## ADDENDUM

**PROJECT:** State of Nebraska  
Grand Island Veteran's Home  
WWII / Phillips Building  
Mechanical, Electrical, and ADA Upgrades  
Grand Island, Nebraska

AD-3

**DATE ISSUED:** Thursday, January 26, 2012

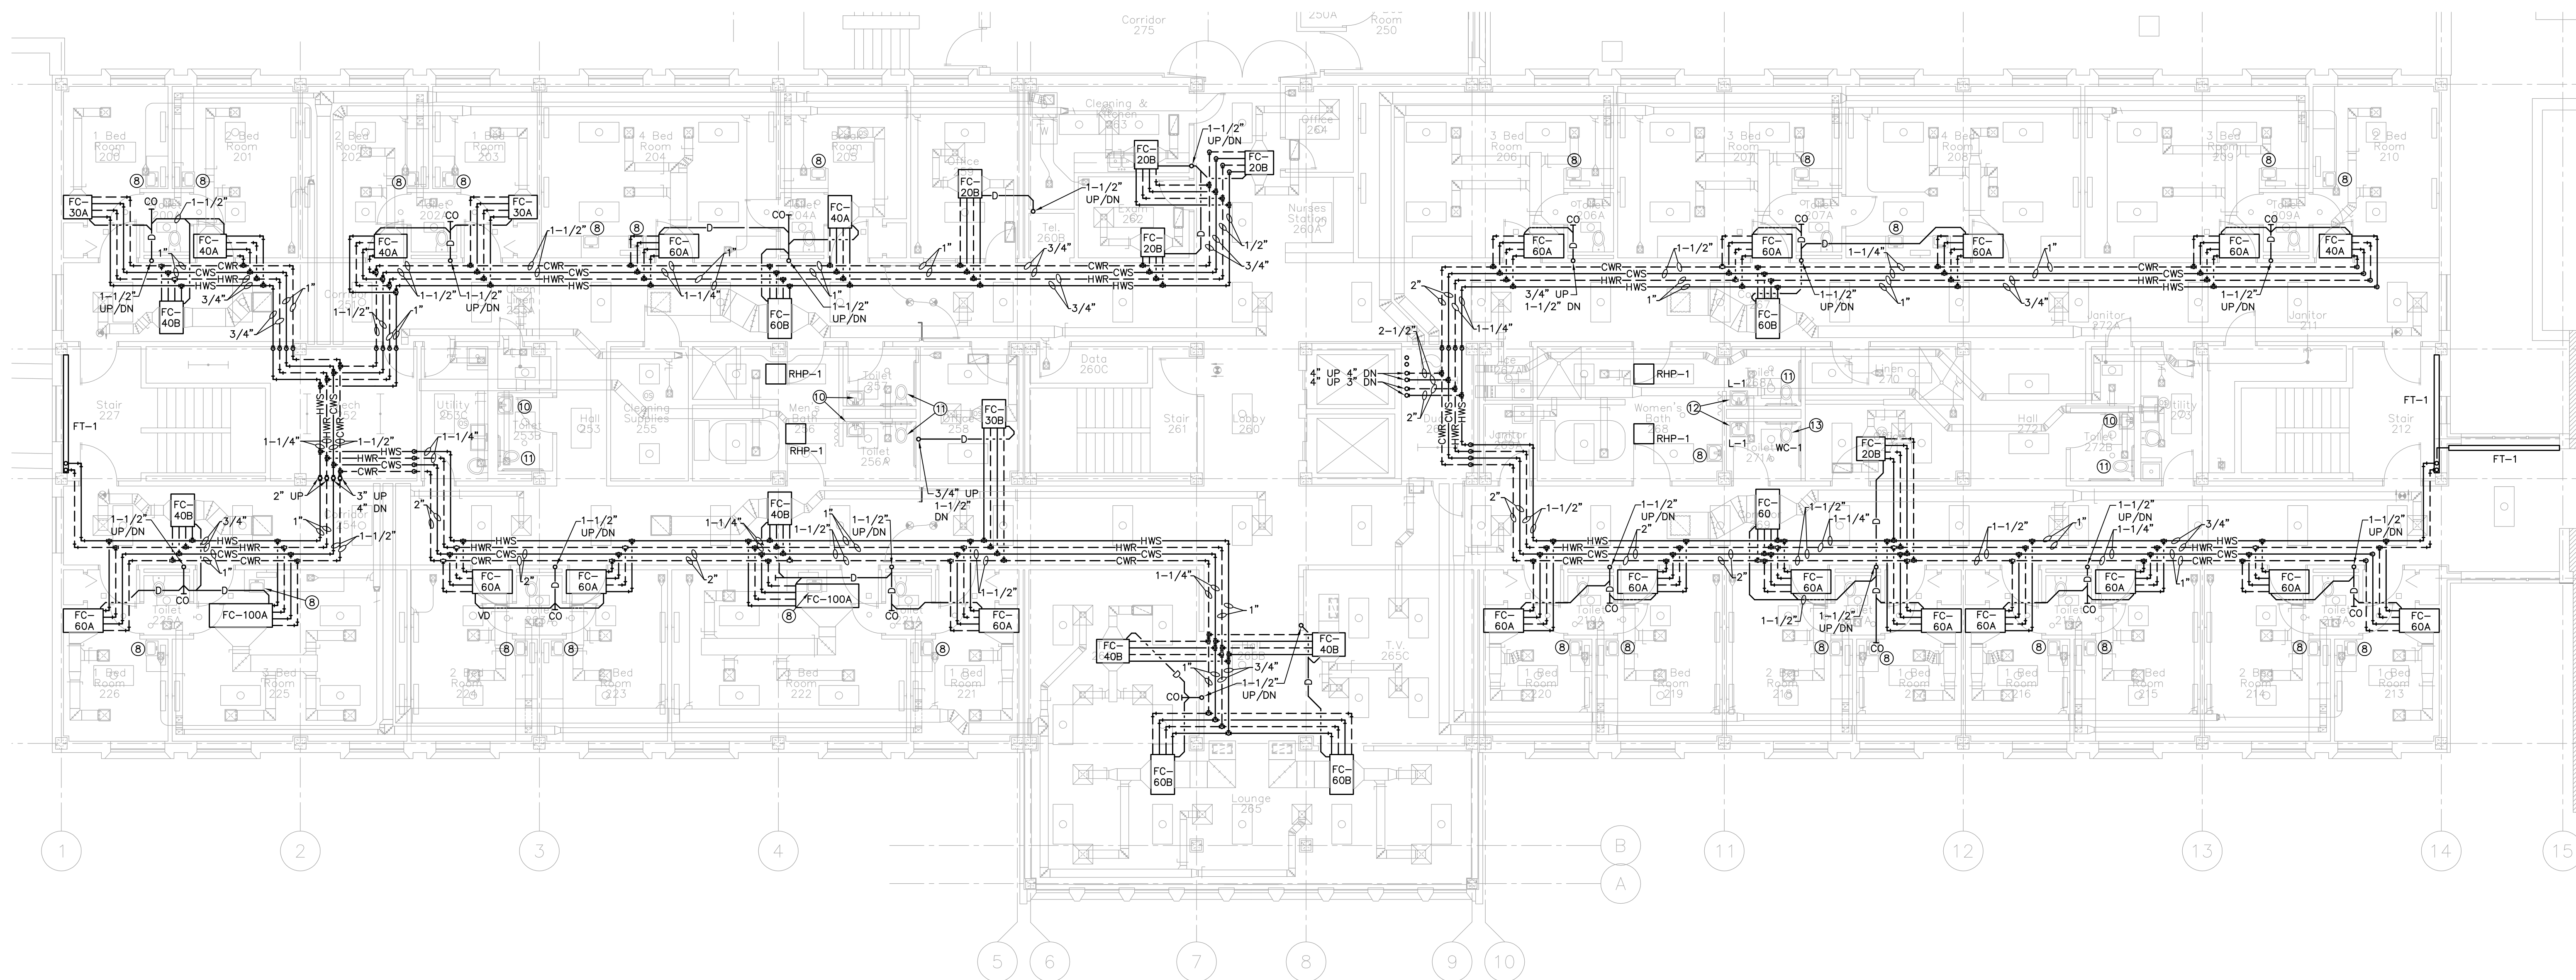
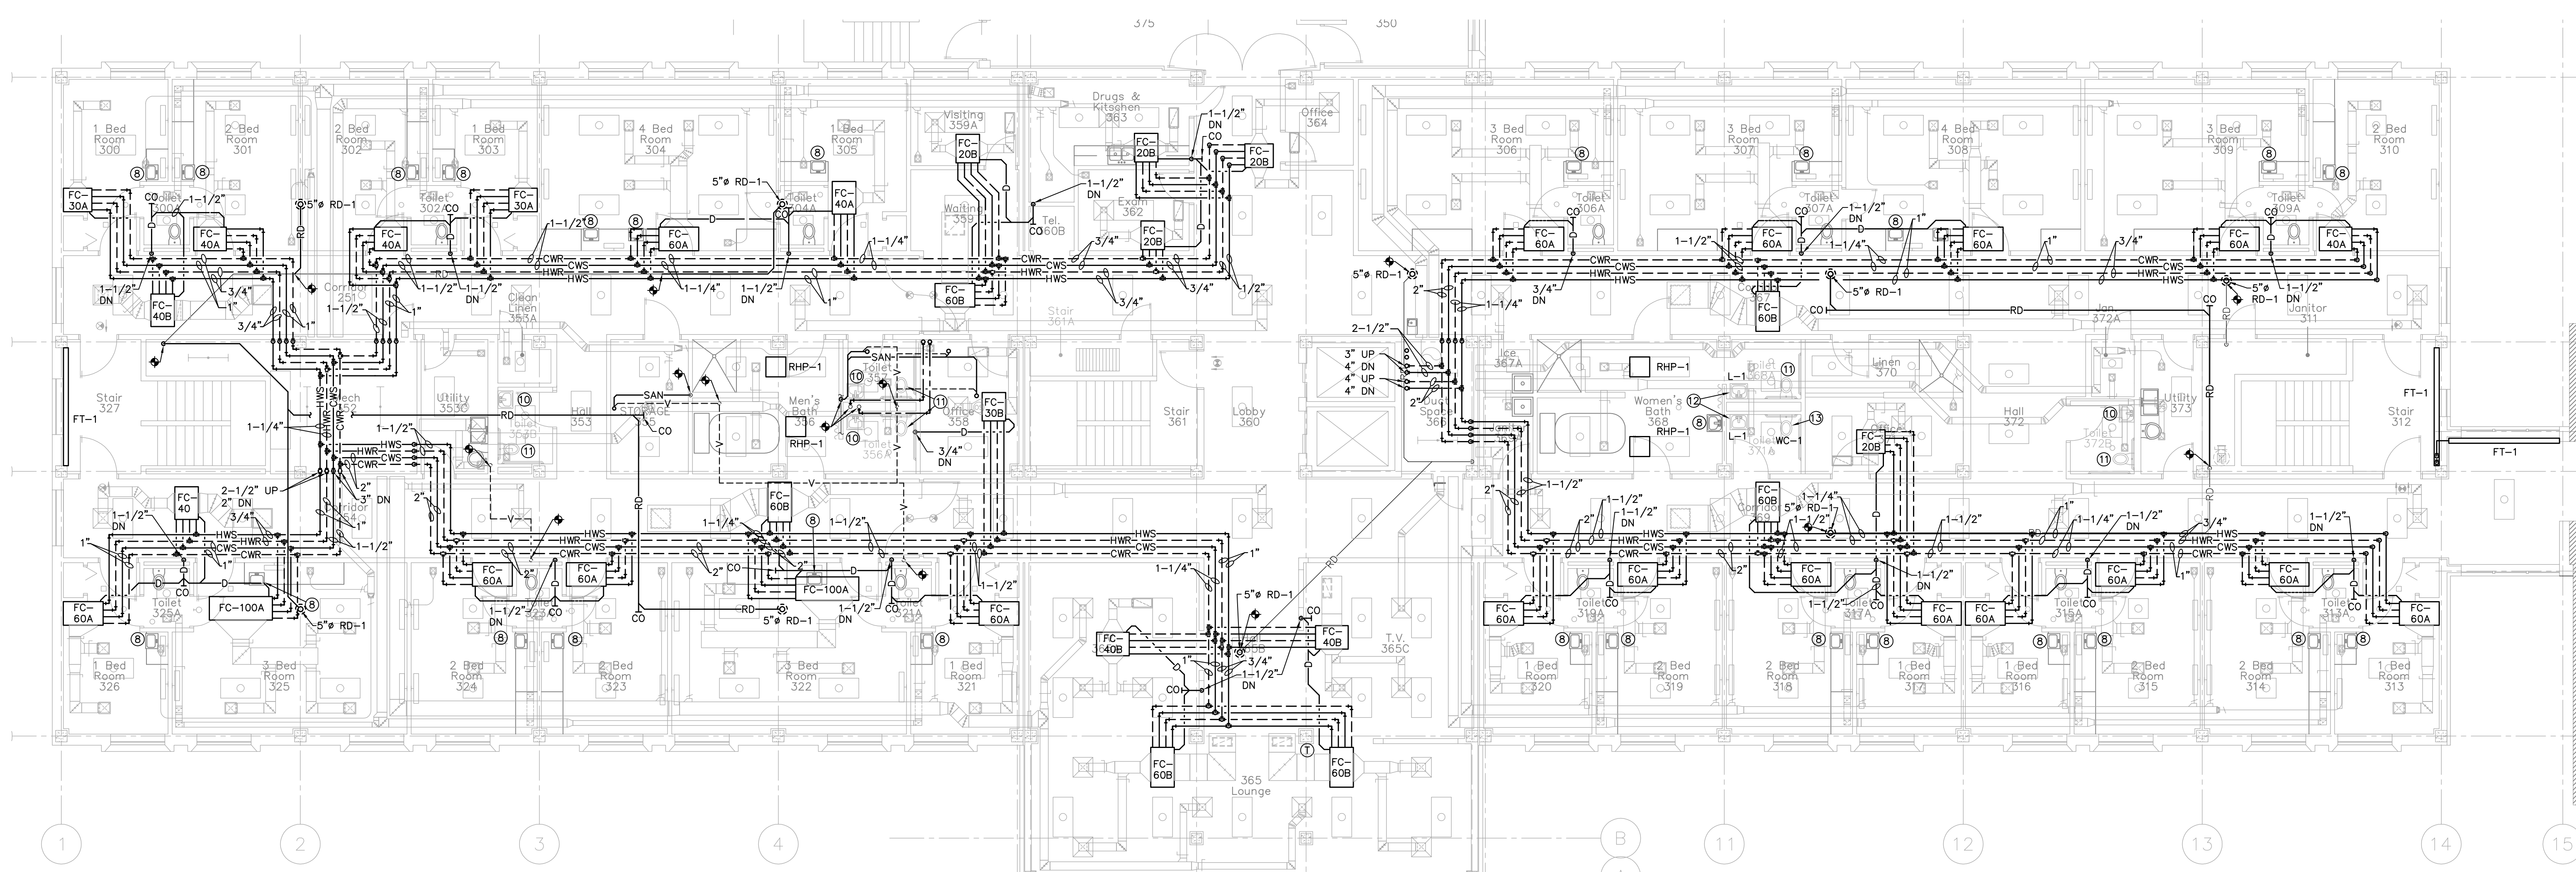
**In reference to drawing M-204**, refer to revised drawing M-204 for changes to piping.

SHEET NUMBER  
**M-205**

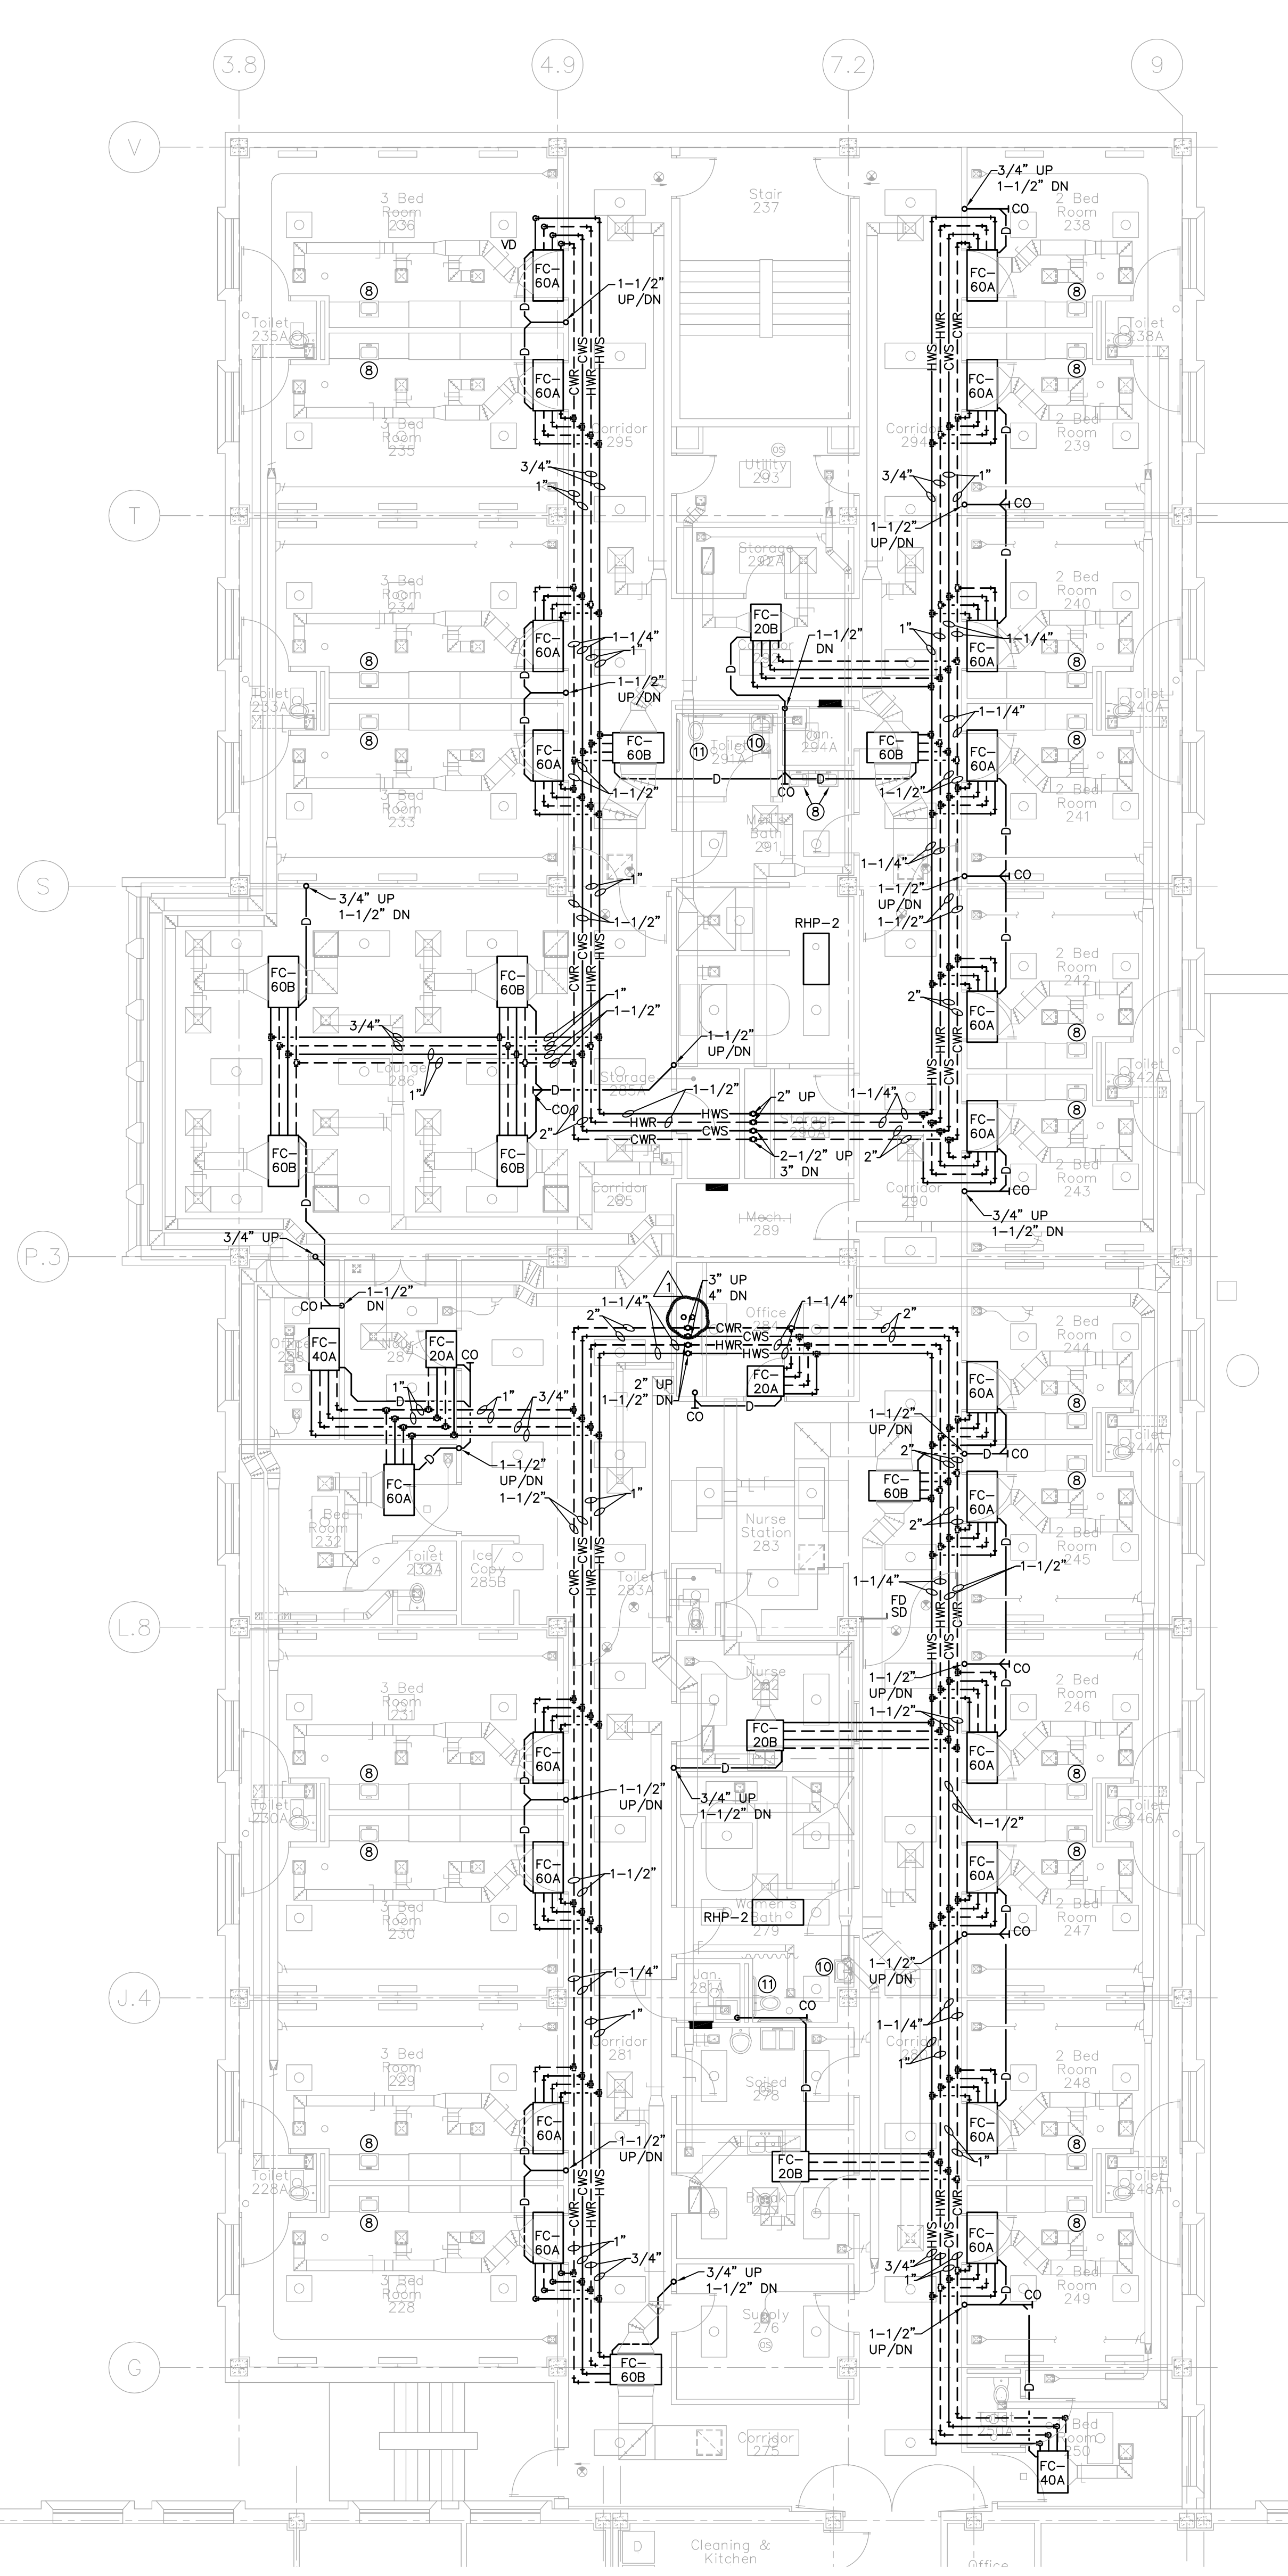
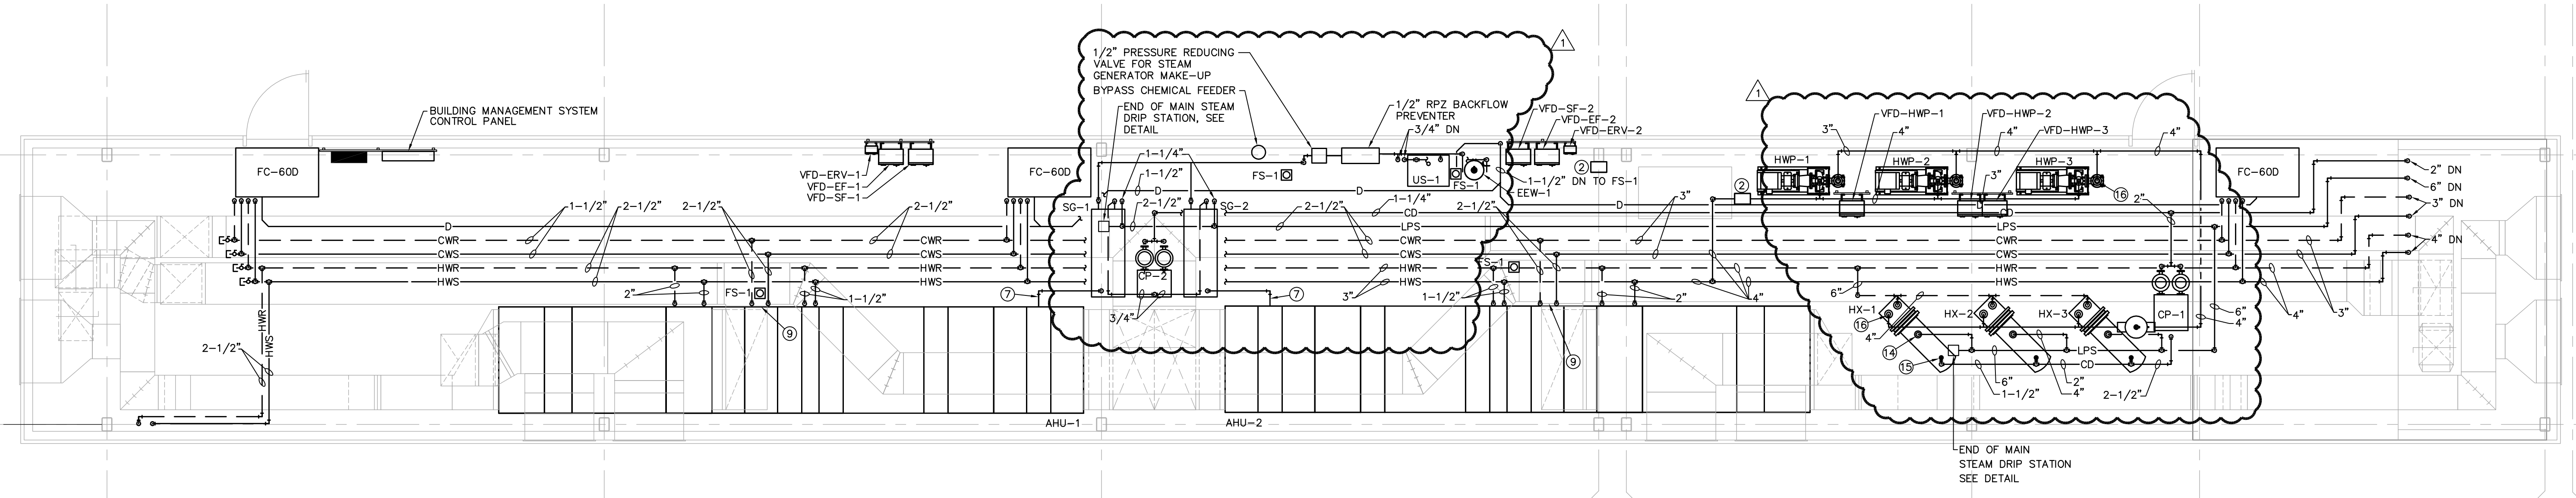
**In reference to drawing M-205**, refer to revised drawing M-205 for changes to piping.

REVISED  
ROOF DRAINS  
& ROOF  
DRAIN PIPING
